NEW ELEMENTARY SCHOOL  
9801 HIGHLAND KNOLLS DR  
BAKERSFIELD  
CALIFORNIA  
93306

SHEET TITLE  
**LIGHTING PLAN**  
**BUILDING H**

SHEET IDENTIFICATION NUMBER  
**E-132H**

RFI 185

LIGHTING PLAN BUILDING H

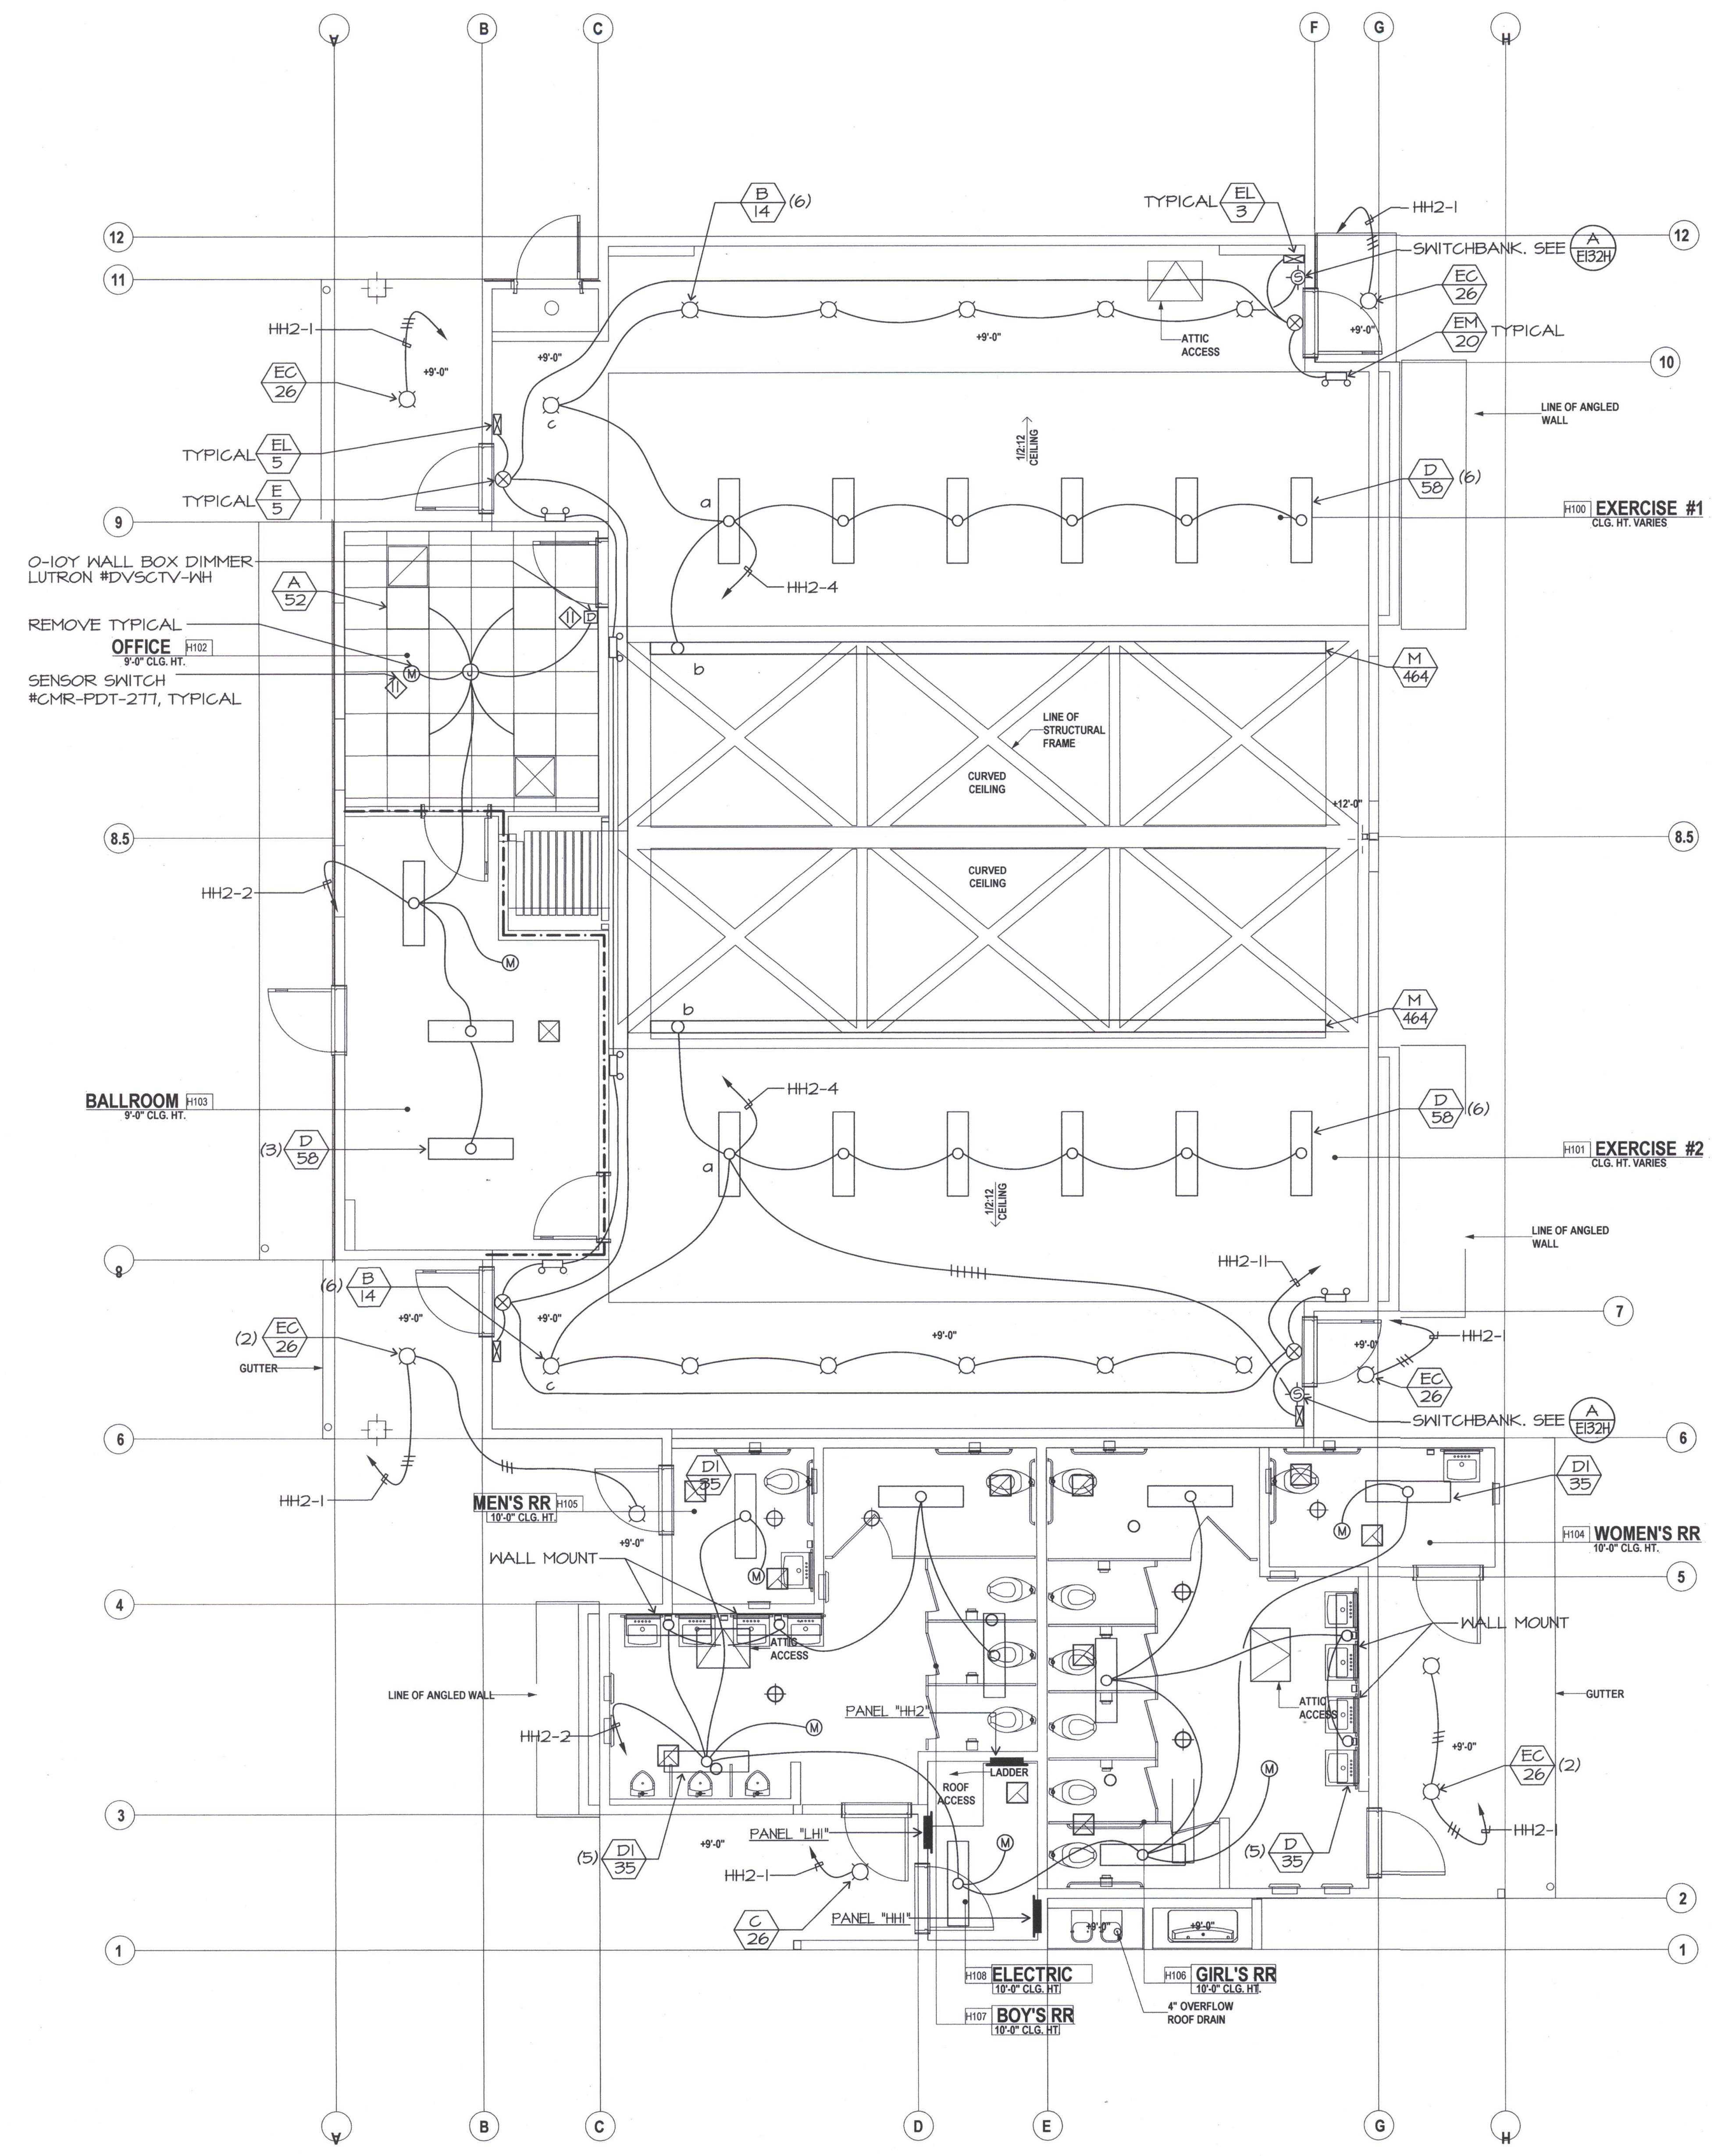
REQUEST:  
RDM Electric - 10/16/12  
Reference Sheets E016 & E-132H  
The Light Fixture Schedule calls out for the Type D light fixture to be 55W. It calls out for the Type D1 light fixture to be 35W, which is typical for restrooms. The Electrical Plan for Building H shows (5) Type D light fixtures to be installed in Room H106, but shows them to be 35W. Should the (5) light fixtures shown in Room H106 be Type D1 and not Type D? Please advise.

ANSWER:  
John Maloney - J.M.P.E. - 11/2/12  
Type D1 is 35 Watts and mounted over mirrors  
Type D is 55 Watts and ceiling mounted  
Type D1 is a 1 lamp fixture  
Type D2 is a 2 lamp fixture
